### STAFF RECOMMENDATION

400 Broadway  
December 20, 2017

**Application:** Signage

**District:** Broadway Historic Preservation Zoning Overlay

(Left) Recent photo of rear addition

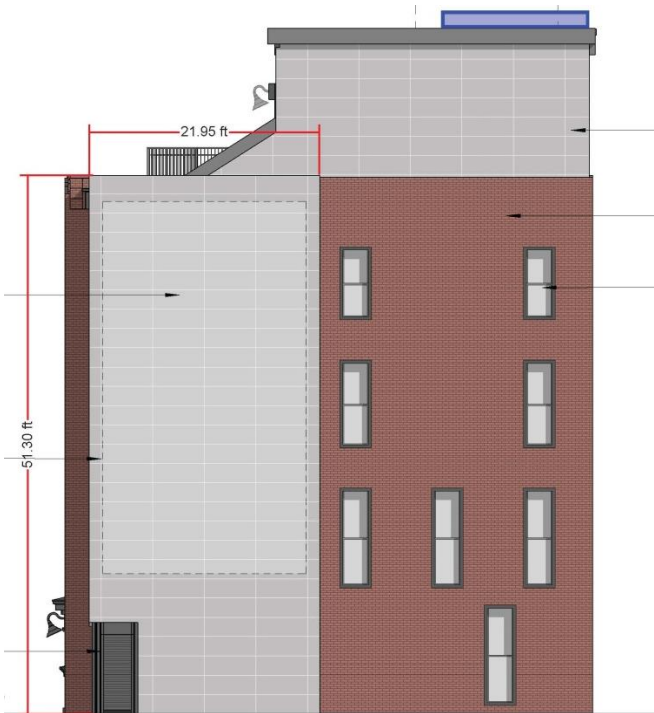
The area where the new painted sign is proposed is approximately twenty-two feet by fifty-one feet (22' X 51'), or one thousand, one hundred and twenty-two square feet (1,122 sq. ft.). The sign/painted mural is significantly larger than the building's allotment of one hundred and twenty-five square feet (125 sq. ft.). In addition, the applicant has a preservation permit for an eighty-six square feet (86 sq. ft.) sign on the 4<sup>th</sup> Avenue North façade. If the 4<sup>th</sup> Avenue North painted sign is installed, then the remaining allotment for painted signage for the building is thirty-nine square feet (39 sq. ft.). The proposed one thousand, one hundred and twenty-two square feet (1,122 sq. ft.) painted sign far exceeds the allotment for the building. Staff therefore finds that the proposed painted sign's size does not meet Section IV. of the design guidelines.

Location: The design guidelines state that painted signs “Should only be added to rear elevations or exposed upper secondary elevations and should not cover transoms, columns, cornices, decorative elements, openings and architectural features or require the enclosure of openings.” The proposed painted sign/mural is proposed for a rear addition, which could be appropriate if the size were within the allotment of one hundred and twenty-five square feet (125 sq. ft.) for the entire building.

**Recommendation Summary:** Staff recommends disapproval, finding that the signage's square footage to be larger than the one hundred and twenty-five square feet (125 sq. ft.) allotted in the design guidelines for painted signs for the entire building. Staff finds that the proposed sign does not meet Section IV. of the design guidelines.
